ADDENDUM NO. 04

Project: Arthur Area Community Centre Renovation

ADDENDUM 02

MECHANICAL

SECOND FLOOR DEMOLITION PLAN – PLUMBING AND DRAINAGE
SCALE: 3/16"=1'-0"

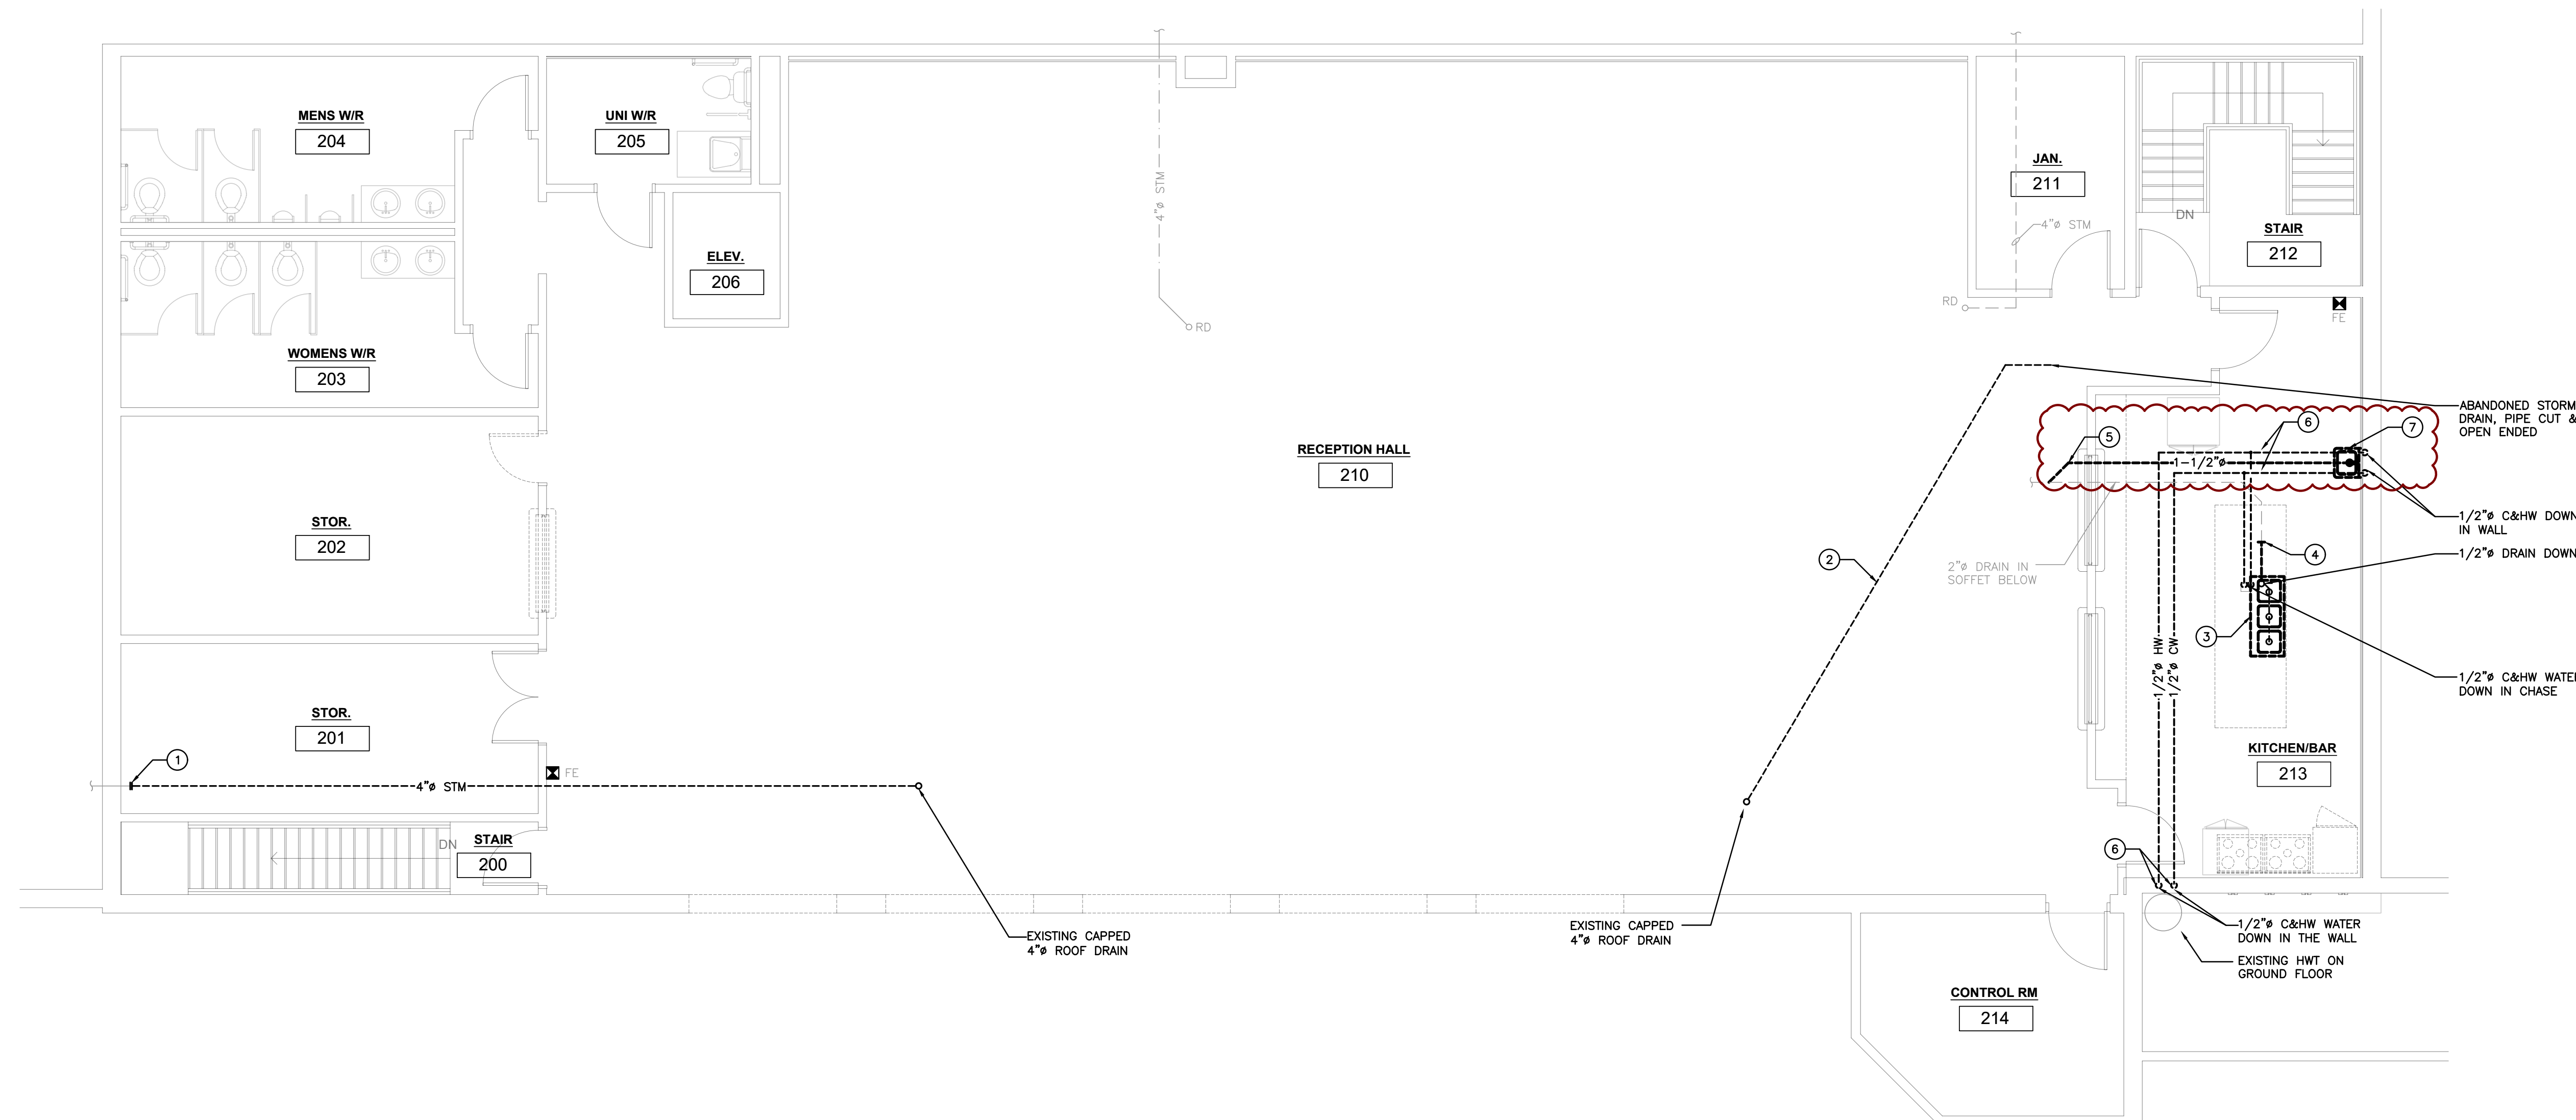
- 3.0 Reference Attached Reissued Drawing M2.1
.1 Piping from existing handwash sink to be removed completely.

SECOND FLOOR RENOVATION PLAN – PLUMBING AND DRAINAGE
SCALE: 3/16"=1'-0"

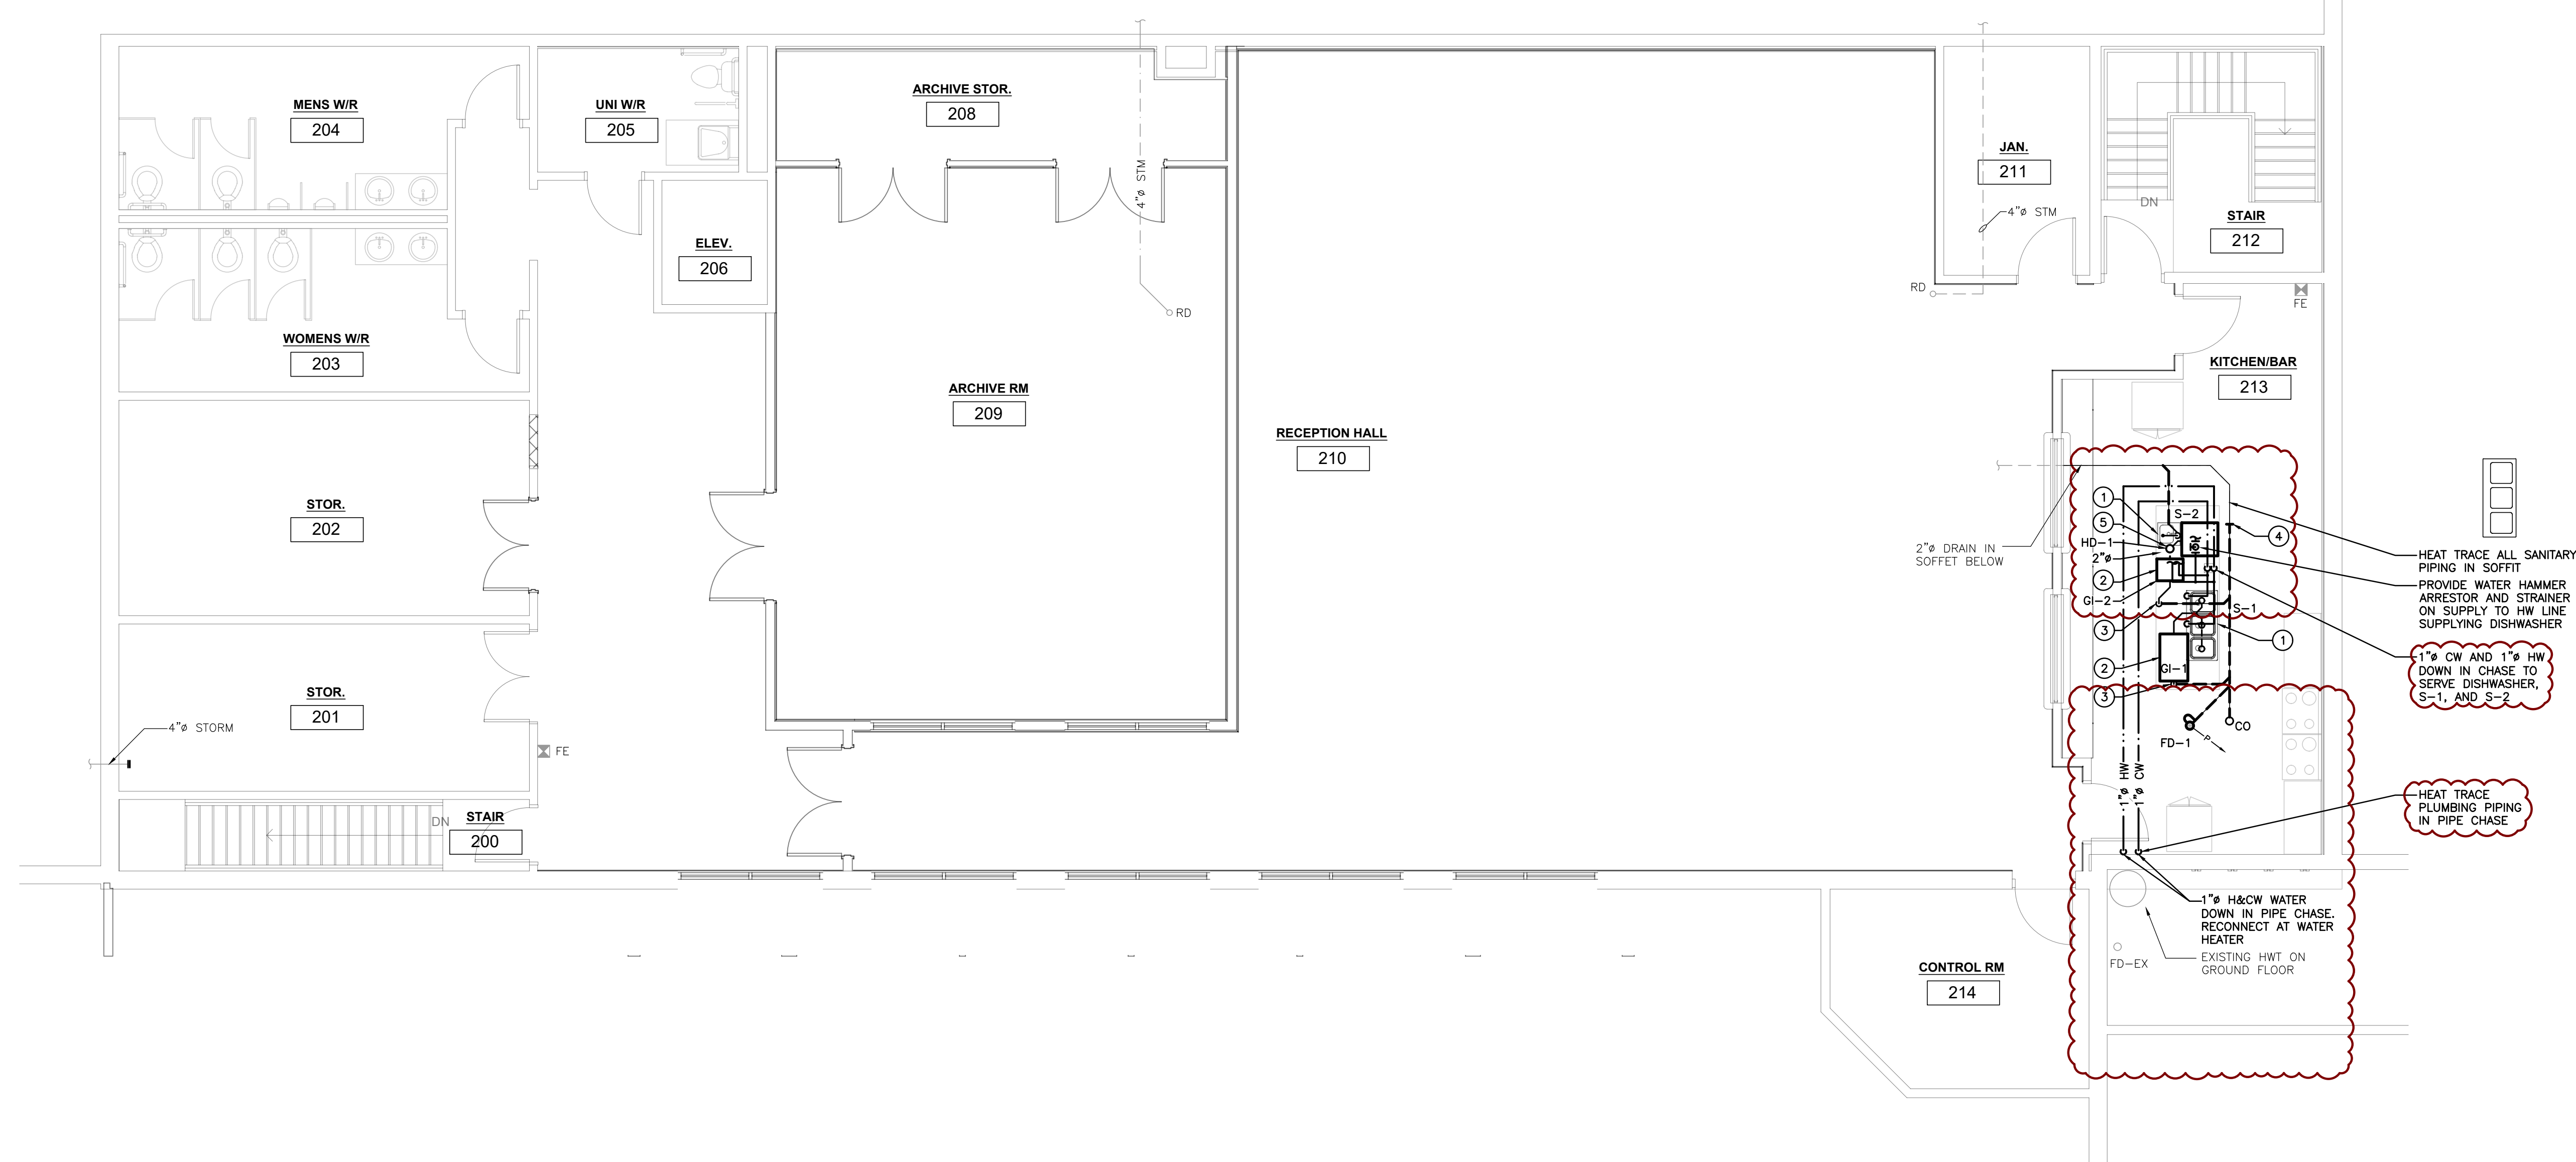
- .6 **Question:**
Note on M3.1 shows drain from new floor drain extending to existing 4"? Would a 2" floor drain be acceptable?
Answer:
Yes, resize to a 2" floor drain

Answer:
As per question 6, resize to a 2"Ø pipe and route to same vertical drop the sink drain line is located.

- 4.0 Reference Attached Reissued Drawing M3.1
.1 New handwash sink moved to kitchen island.
.2 Trap added to drain from FD-1.
.3 Heat tracing added to hot and cold water lines in pipe chase.

SECOND FLOOR RENOVATION PLAN – HVAC
SCALE: 3/16"=1'-0"

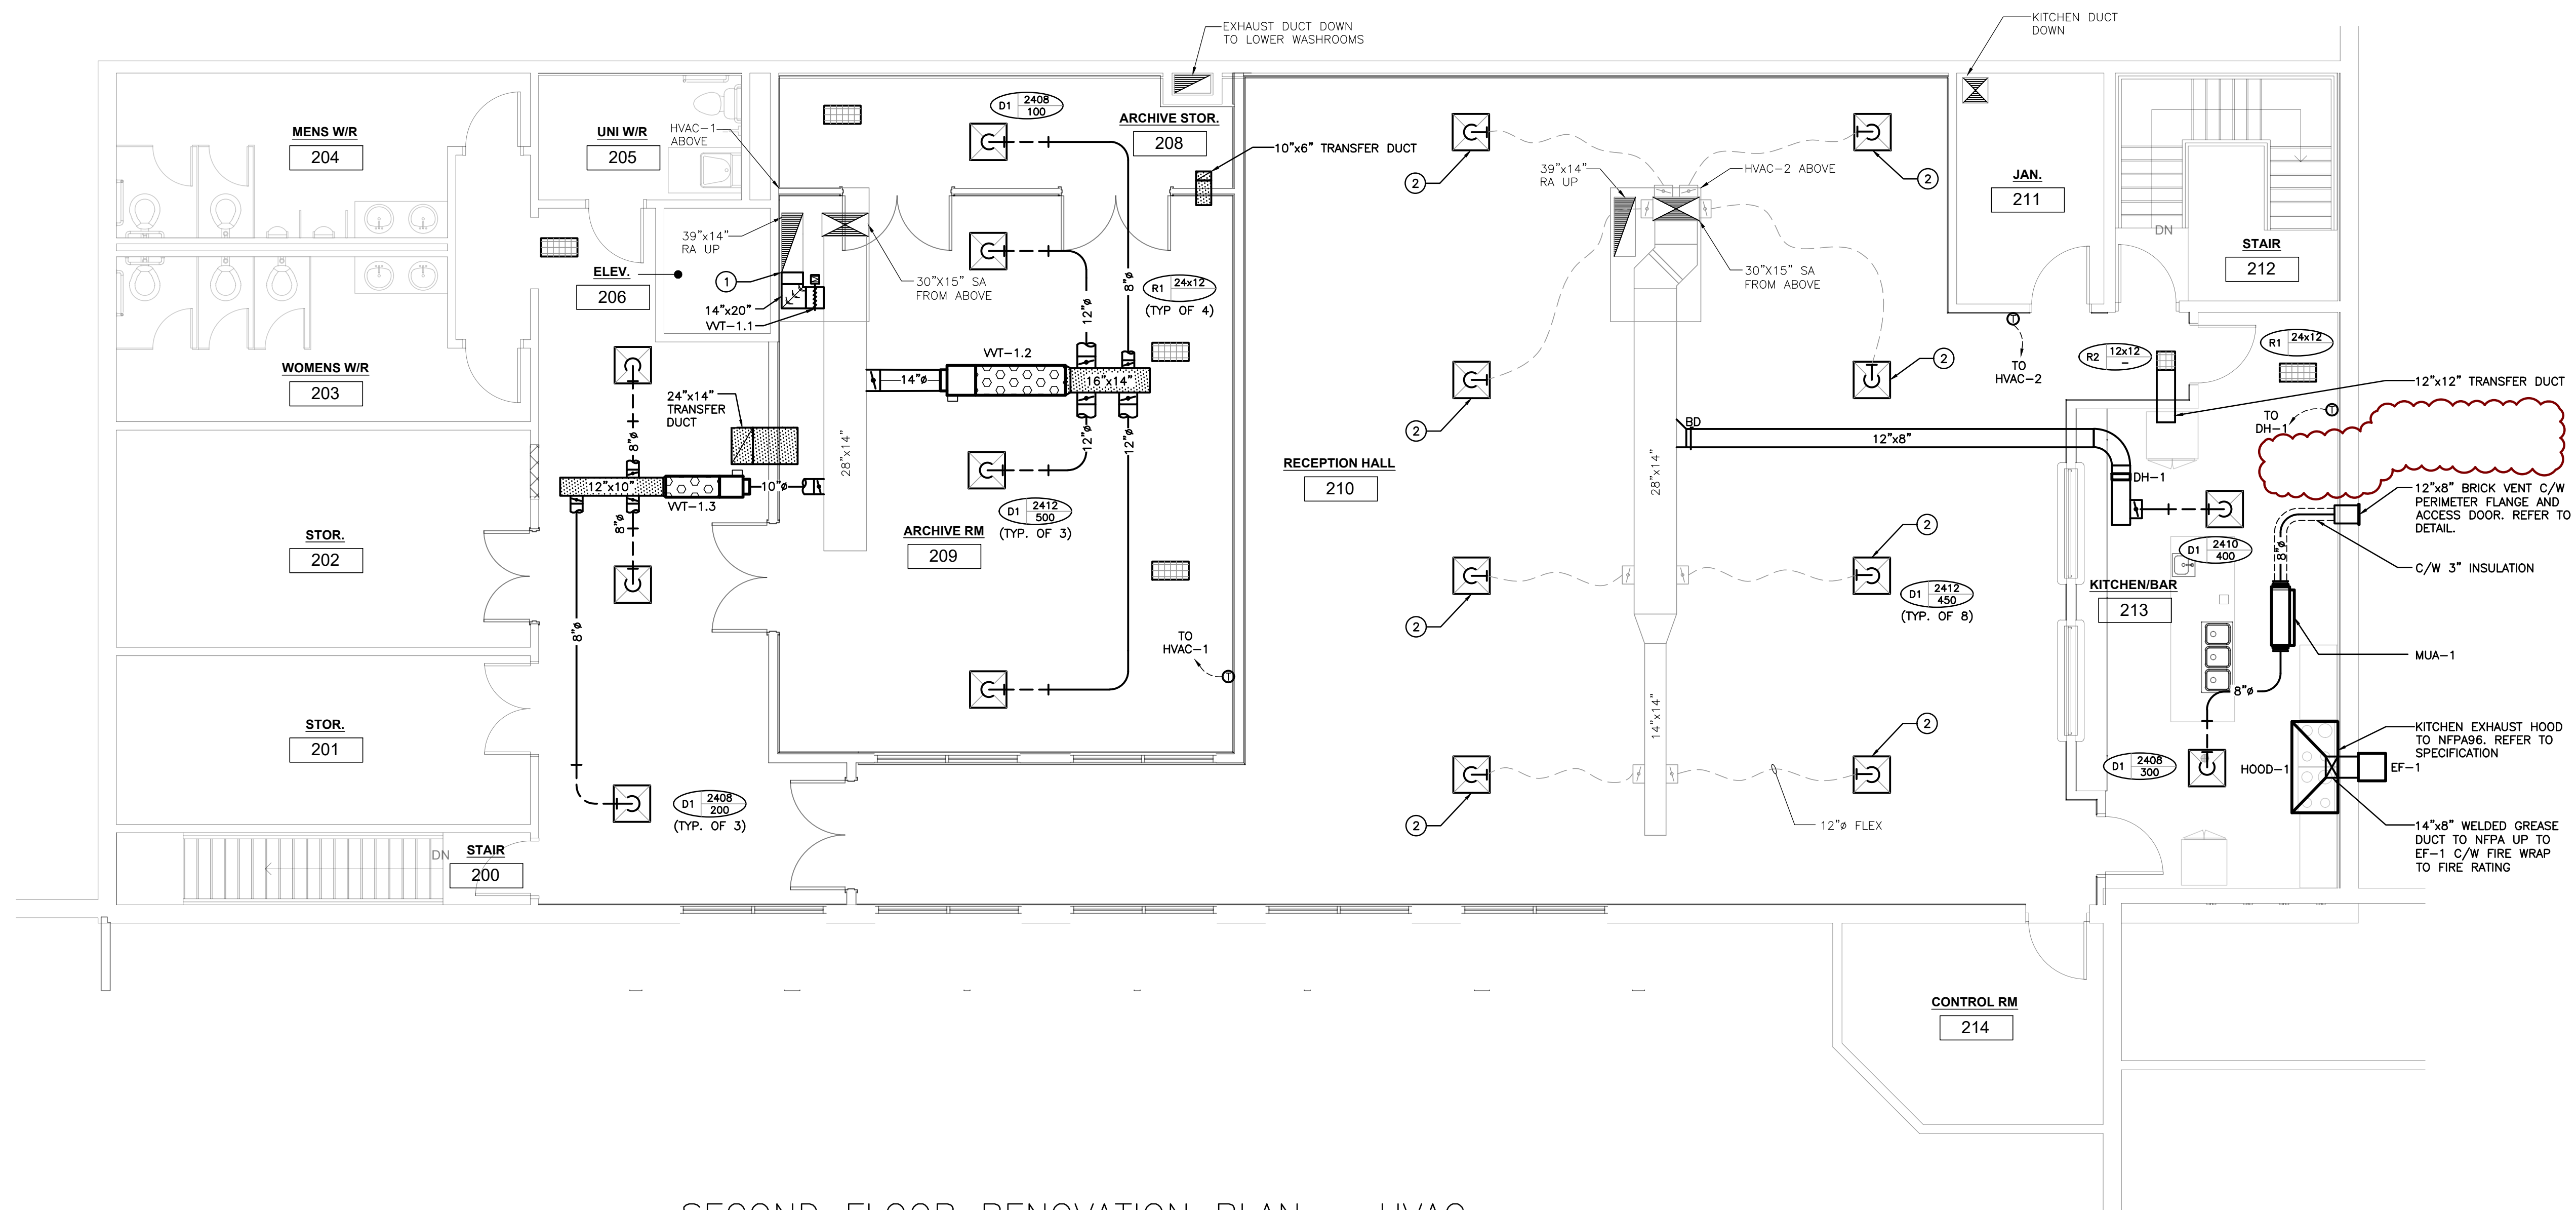
- 5.0 Reference Attached Reissued Drawing M3.2
.1 Grilles for exterior wall chase removed.
